Access Compliance Report

Public Rights-of-Way

(Curb Ramps)

Intersection ID: 10038802	Main Street: STEELE_CREEK_RD	Cross Street: N/A	Location: SE
ADA ID: 637D27B0B1ED	Ramp Type: BlendTrans2	Initial Pass/Fail: Fail	Overall Compliance: No
Codes/Mitigation Info/Possible Solution		Field Measurements/Component Compliance	
Severity Score: 10

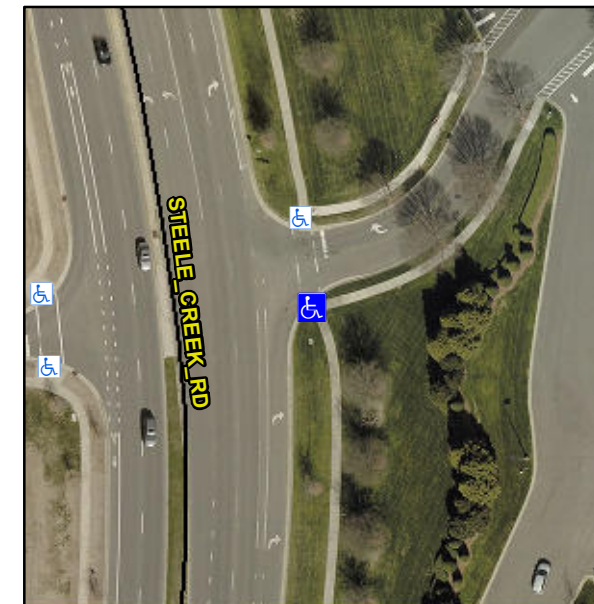
Not Found, R304.5.1, R304.5.3

Compliance	Description	Data	Compliance	Description	Data
N/A	Ramp Length (in)	69.0	Yes	BlendTrans Slope (%)	3.9
No	Ramp Width (in)	38.0	No	BlendTrans XSlope (%)	3.5
N/A	Flare Type LT	N/A	N/A	Flare Type RT	N/A
N/A	Flare Slope LT (%)	N/A	N/A	Flare Slope RT (%)	N/A
N/A	Flare Traversable LT?	N/A	N/A	Flare Traversable RT?	N/A
N/A	Landing Length (in)	N/A	N/A	DWS Provided?	N/A
N/A	Landing Width (in)	N/A	N/A	DWS Contrast?	N/A
N/A	Landing Slope (%)	N/A	N/A	DWS Length (in)	N/A
N/A	Landing X Slope (%)	N/A	N/A	DWS Full Width?	N/A
N/A	Landing Curb? (Y/N)	N/A	N/A	DWS Offset (in)	N/A
N/A	Shared Landing?	N/A			
N/A	Gutter Ponding?	N/A	N/A	Gutter Slope (%)	N/A
N/A	Gutter Lip Ht (in)	N/A	N/A	Gutter X Slope (%)	N/A
N/A	Painted X Walk1?	Yes	N/A	Painted X Walk2?	No
	X Walk 1 Direction	To N		X Walk 2 Direction	To SW
	X Walk 1 Width (in)	113.0		X Walk 2 Width (in)	N/A
	X Walk 1 Slope (%)	1.6		X Walk 2 Slope (%)	0.6
	X Walk 1 X Slope (%)	0.7		X Walk 2 X Slope (%)	0.7

N/A	Ramp inside XWalk1?	Yes	N/A	Ramp inside XWalk2?	N/A
	Road Slope (%)	0.6		Clear Space?	N/A
	Road X Slope (%)	0.3	N/A	Clear Space to XWalk (in)	N/A
N/A	Any Obstructions?	N/A	N/A	Storm Grate/Utility Hazard?	N/A
	Obstruction Type			Storm Grate/Utility Type	
		N/A			N/A
			Yes	Surface Condition? (G/P)	Good
			No	Curb Slope (%)	12.3

Remove & Replace Curb Ramp With Two New Directional Ramps or Equivalent.
